## Response to Infrastructure Improvements

# A4 Bath Road

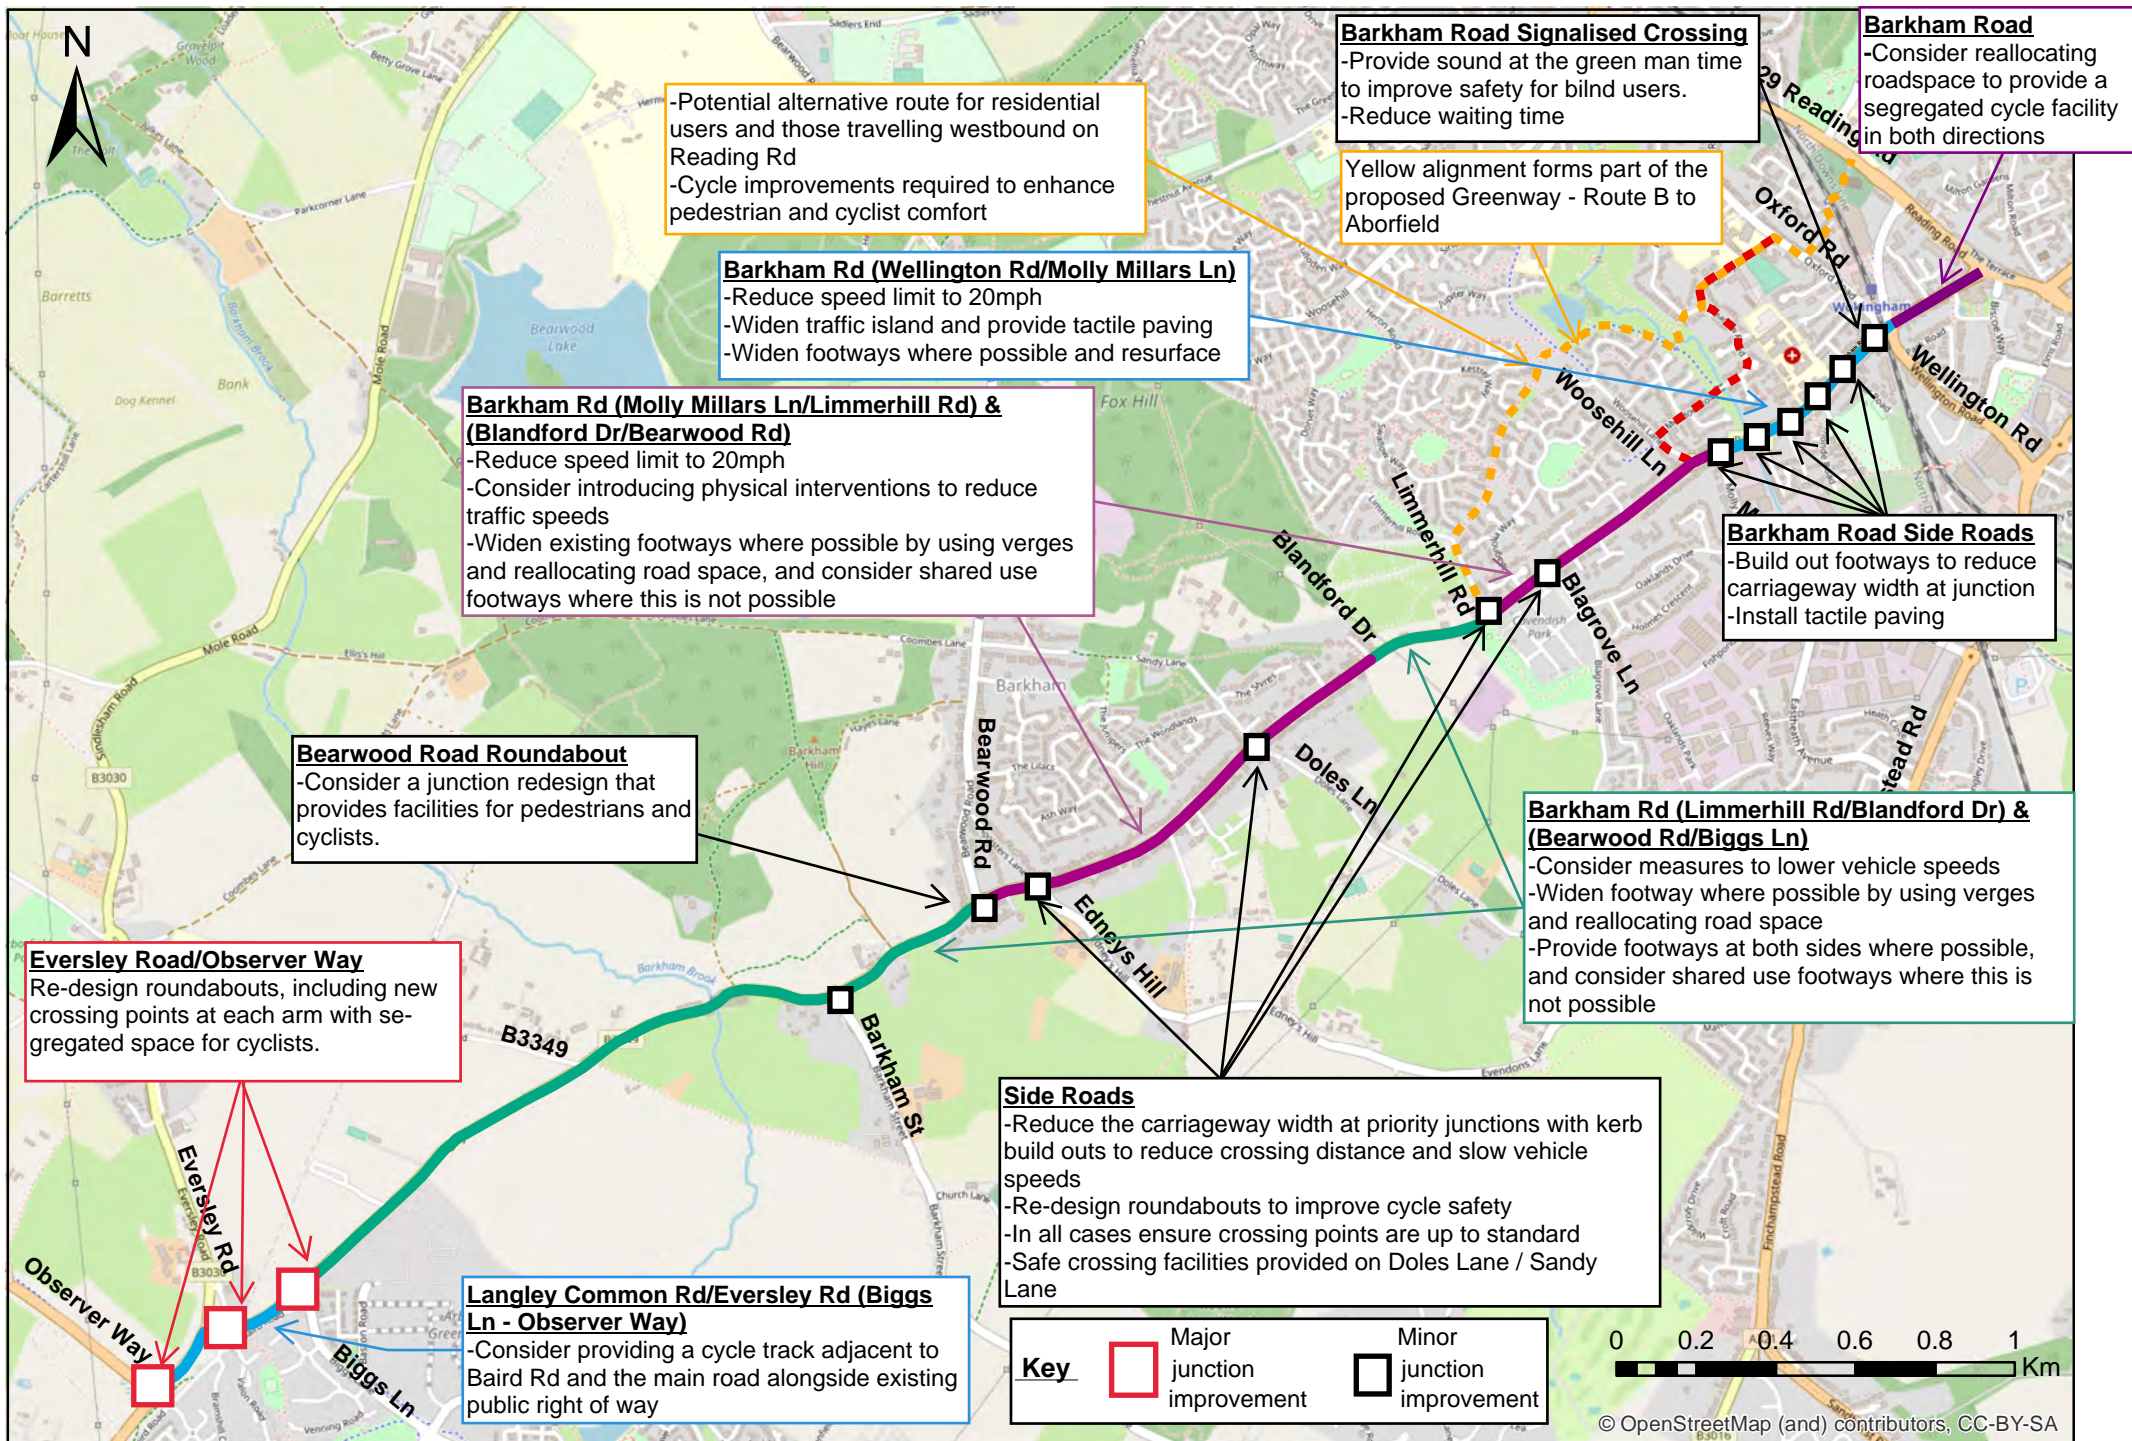
| Issue raised  | Change to the plans  |
|---|--|
| Compliance with reduced speed limits will be low                        | Before speeds limits are reduced, consideration to traffic calming measures will be given to ensure speed limits are self enforcing  |
| Speed limits should not be reduced.                                     | Before speeds limits are reduced, consideration to traffic calming measures will be given to ensure speed limits are self enforcing.   |
| Signalisation of Bath Road Roundabout will cause congestion             | Congestion impacts of proposals will be reviewed and modelled at future design stages. However, non-signalised options that provide pedestrian and cycle facilities will be considered. Plan updated to make this clear. |
| Right turning movements from A4 Bath Road to Sonning Lane are dangerous | A right turn ban or signalised turn will be considered   |

**London Road**

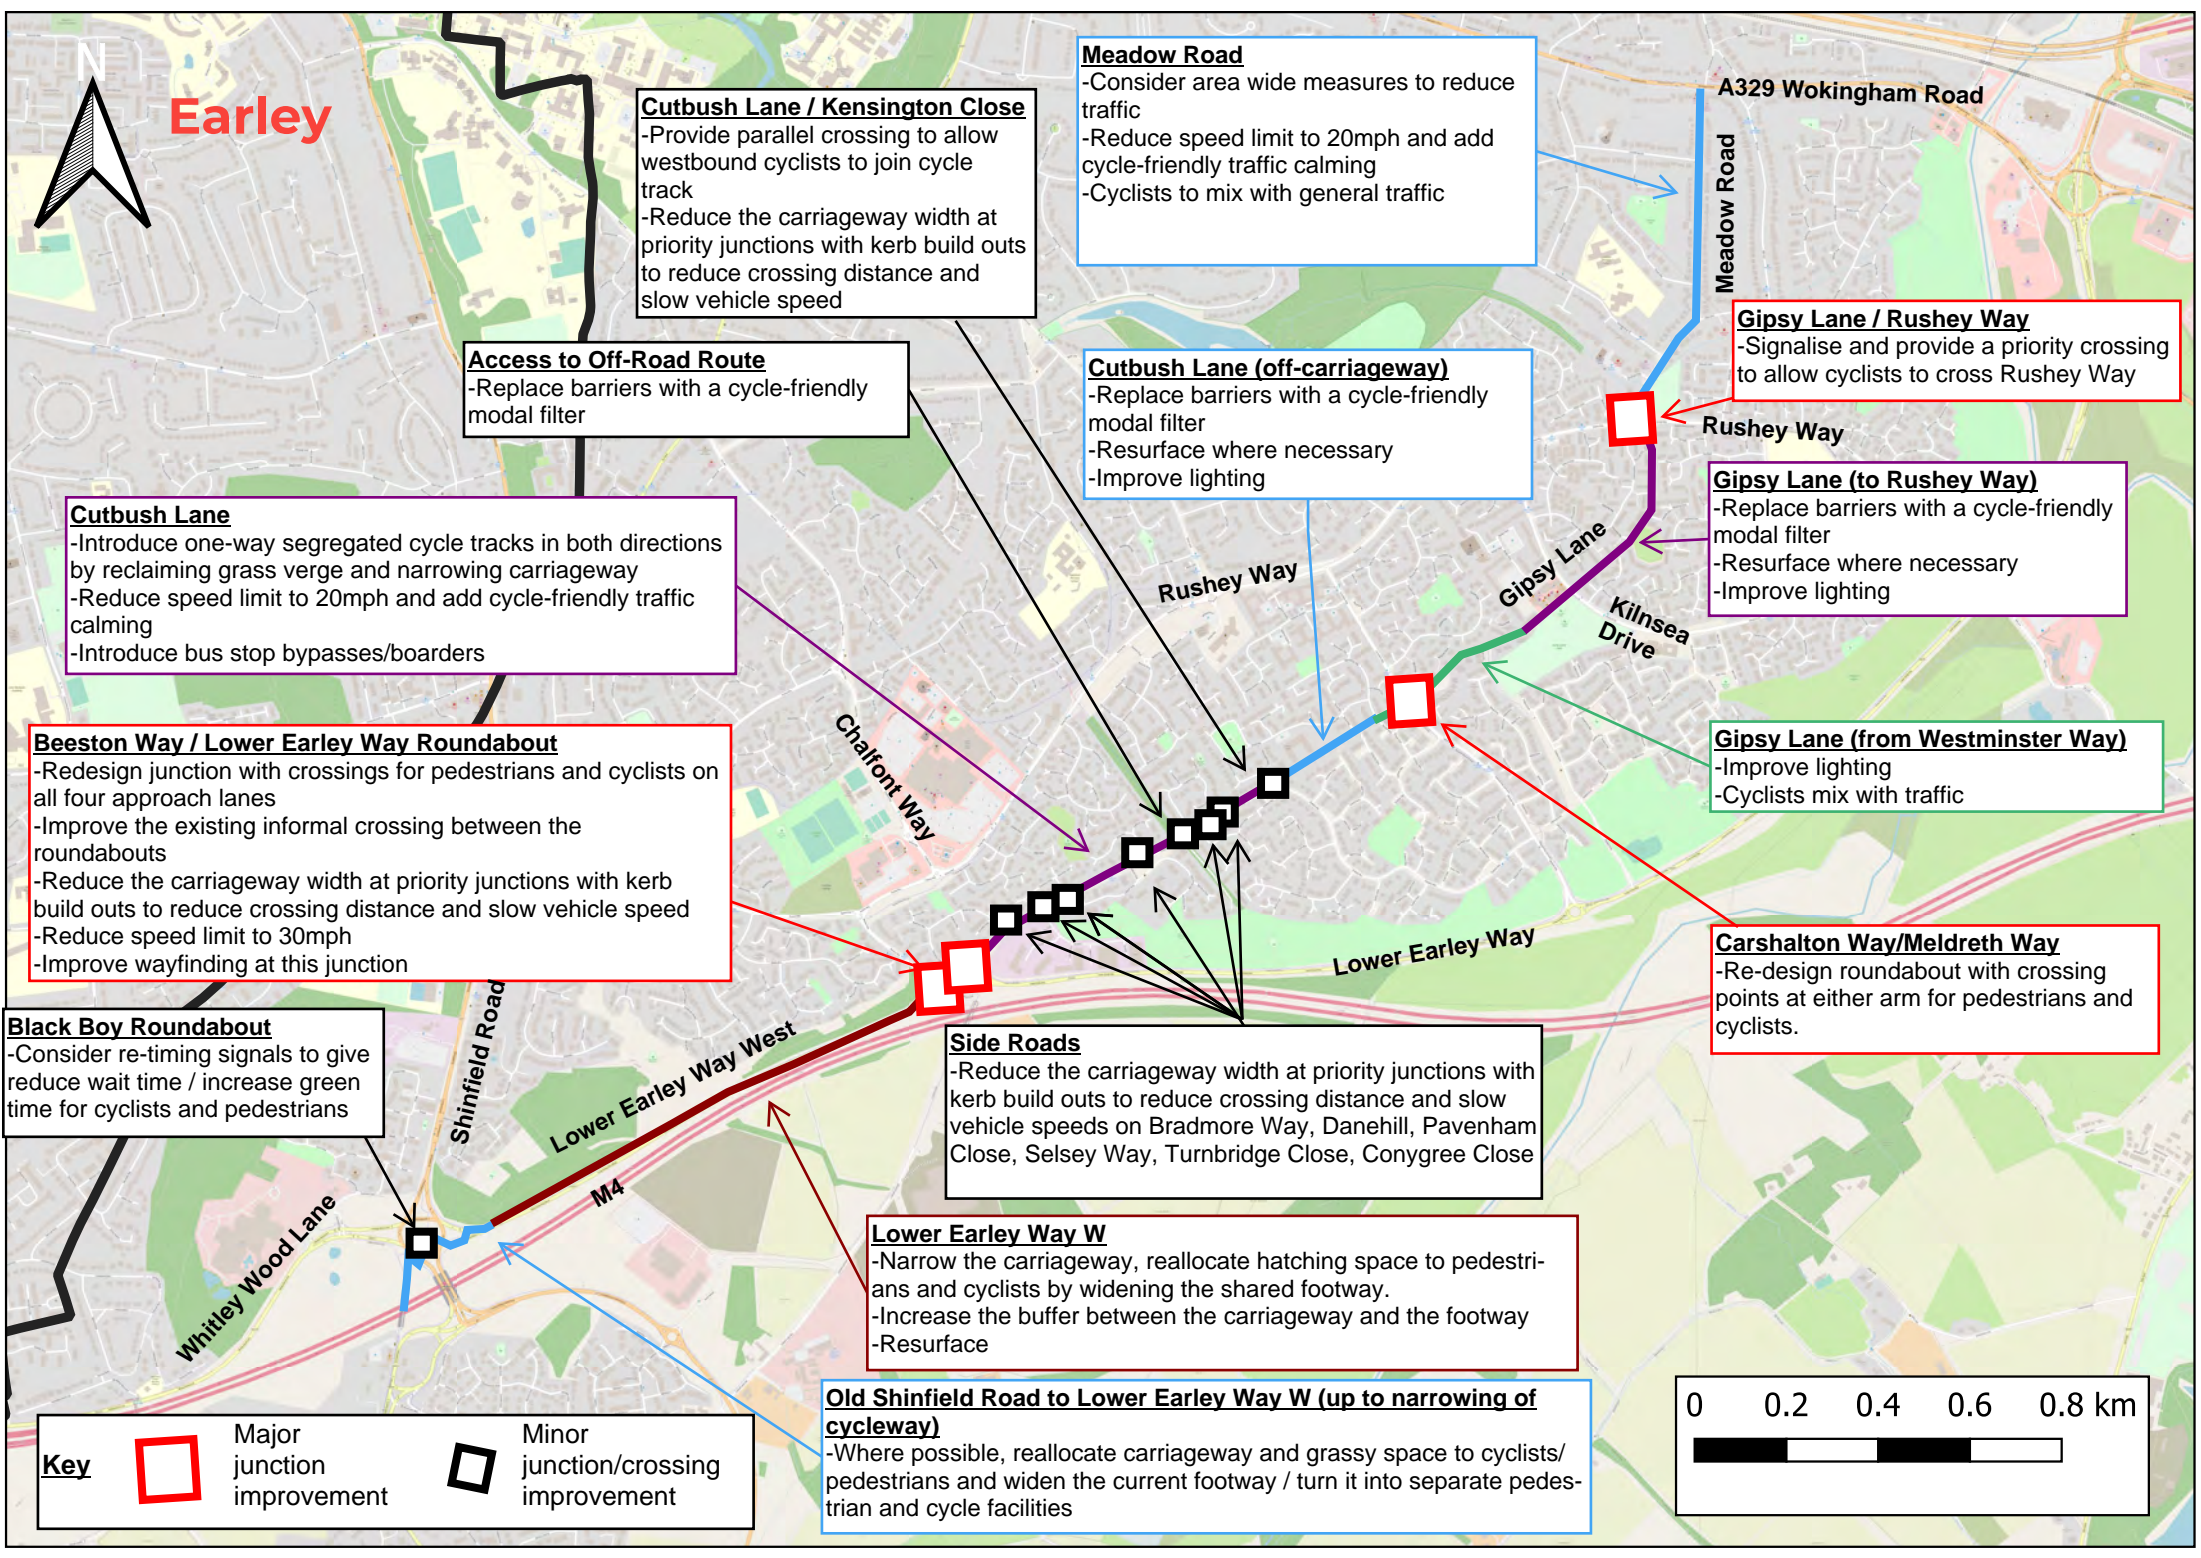
| Issue raised   | Change to the plans   |
|--|---|
| Concerns that Rances Lane was being excluded from 20mph limits.  | Plans amended to include Rances Lane in a 20mph zone.   |
| Concerns that proposed cycleways cannot be accommodated within highway extents.  | Plans amended to highlight proposals dependent on a review of the highway boundary. This will be further assessed as part of the next design stage. |
| Concerns speed limits won't be consistent, as no speed limit shown for the section of London Road between Wiltshire Road and Seaford Road. | Plans amended to clarify speed limits for this section.   |
